Licence Number	L8621/2011/1
Licence Holder	Roy Hill Iron Ore Pty Ltd
ACN	123 722 038
Registered business address	5 Whitham Road PERTH AIRPORT WA 6105
Date of amendment	13 January 2017
Prescribed Premises	Category 5 – Processing or beneficiation of metallic or non-metallic ore Category 6 – Mine dewatering Category 12 – Screening, etc. of material Category 54 – Sewage Facility Category 57 – Used tyre storage (general) Category 64 – Class II putrescible landfill site Category 73 – Bulk storage of chemicals, etc.
Premises	Roy Hill Iron Ore Mine M46/518 and M46/519 NEWMAN WA 6753

Amendment

Amendment Notice

Amendment Description

Figure 1. Location of evaporator discharge points within Premises boundary

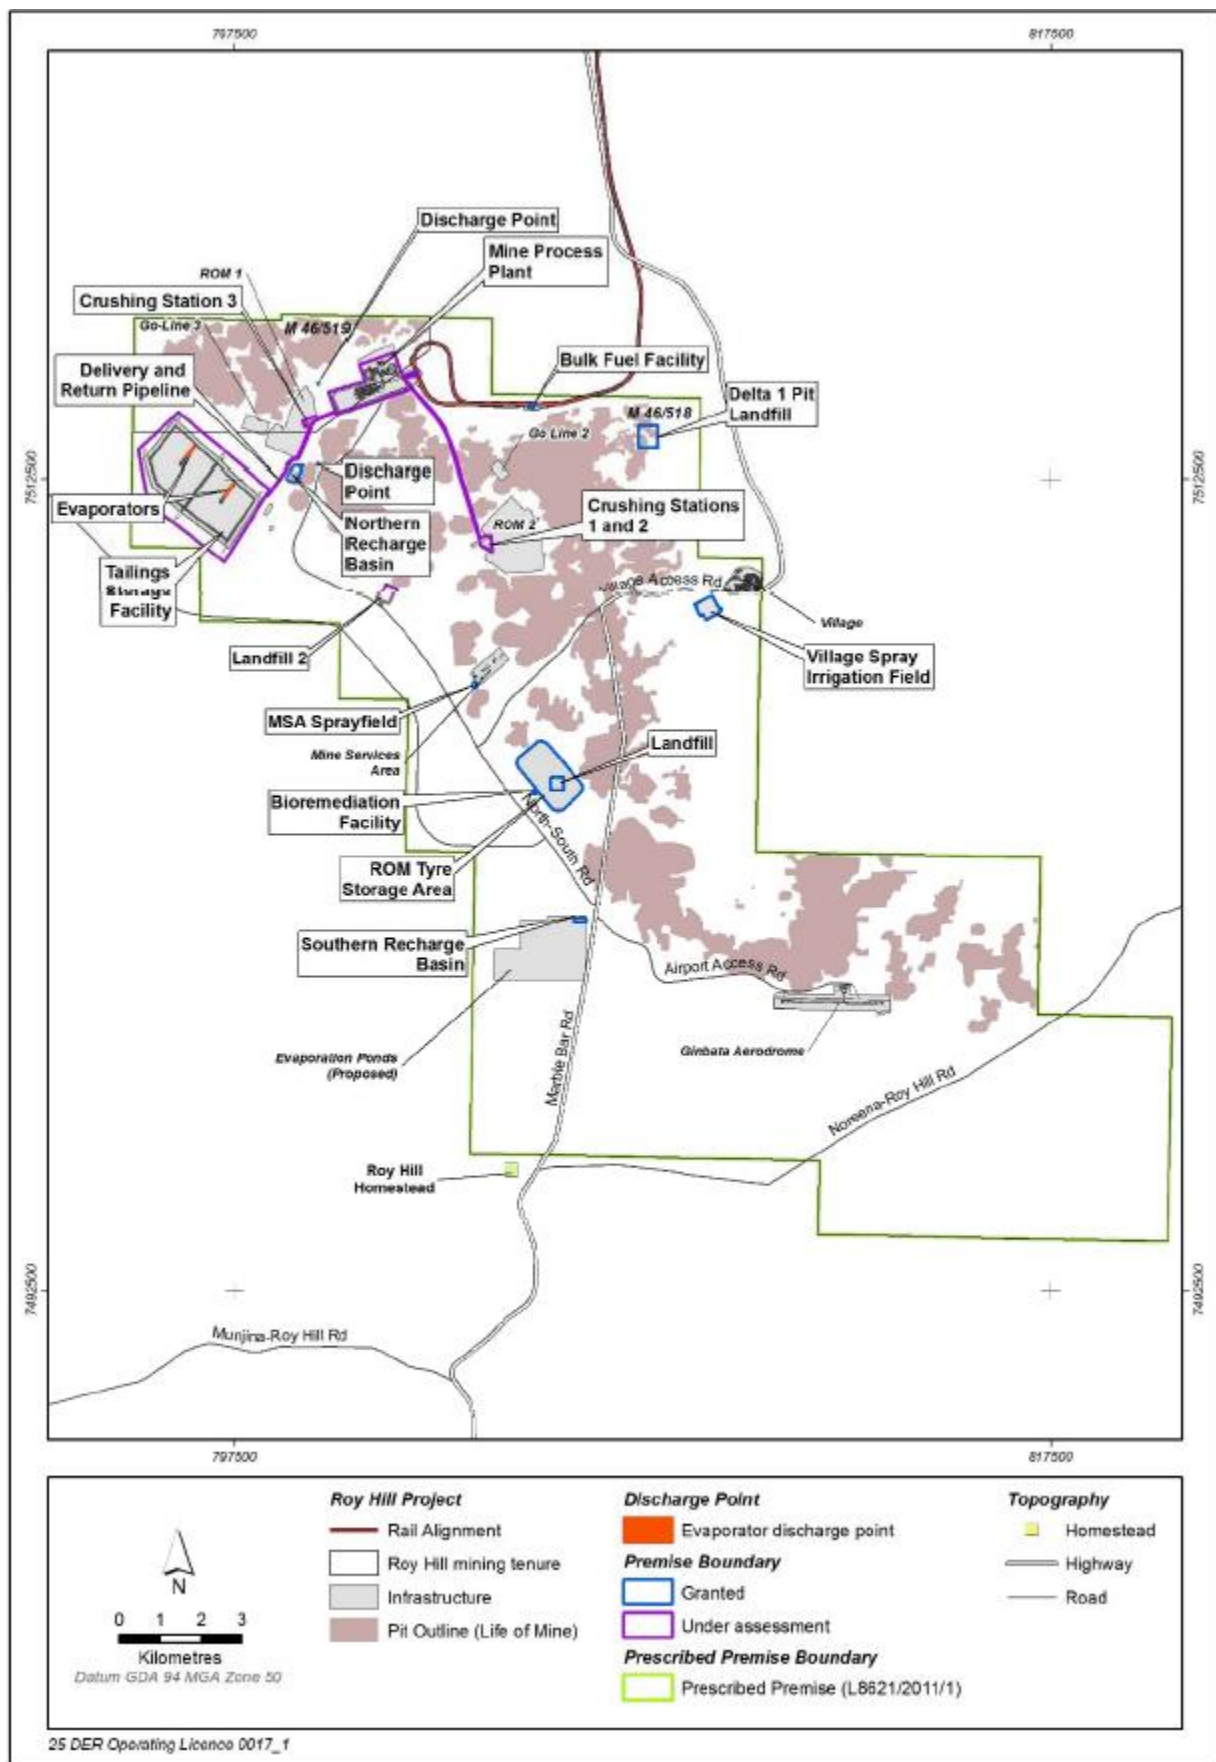
The location of the evaporators (highlighted in orange) is depicted in the TSF (Figure 1, below) and in greater detail in Figure 2 (yellow dots).

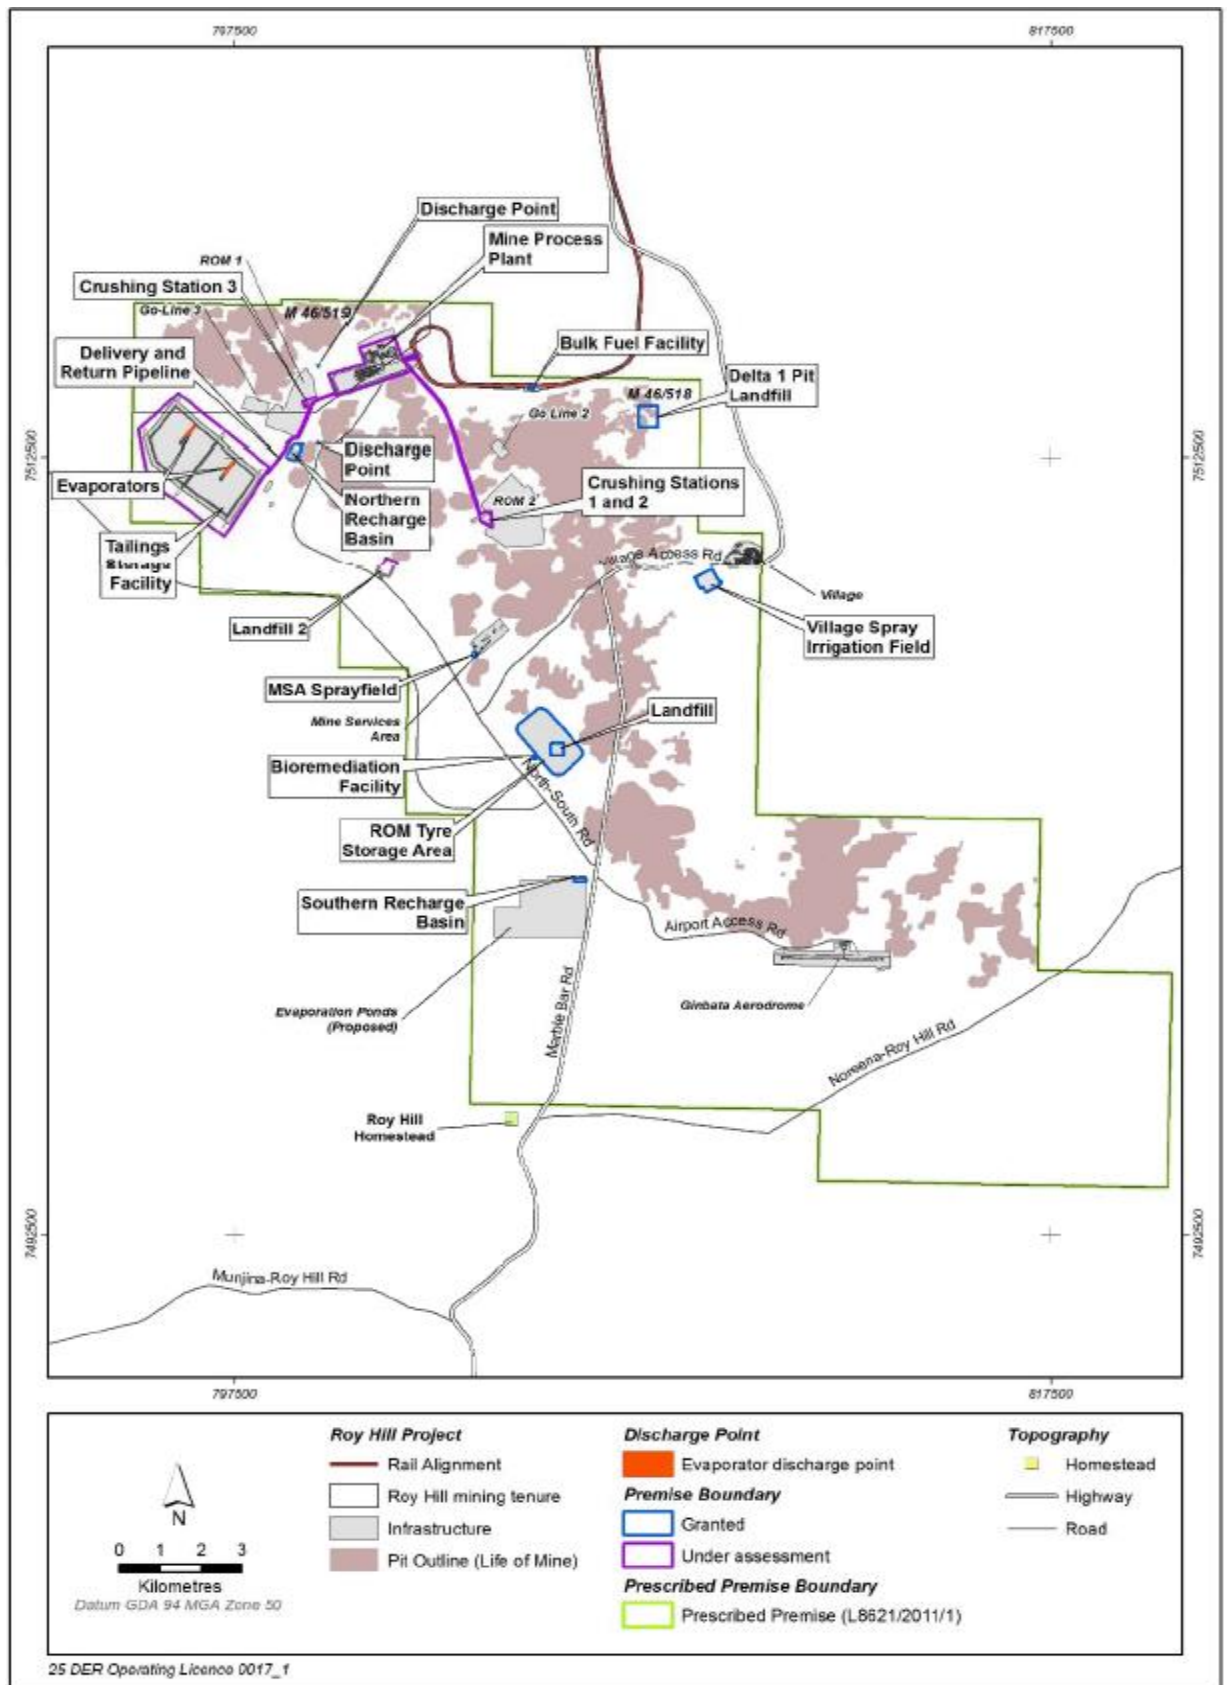
4. The Licence is amended by the replacement of the Schedule 1 map with the following map. This map includes the evaporators (as highlighted in orange) within the Tailings Storage Facility.
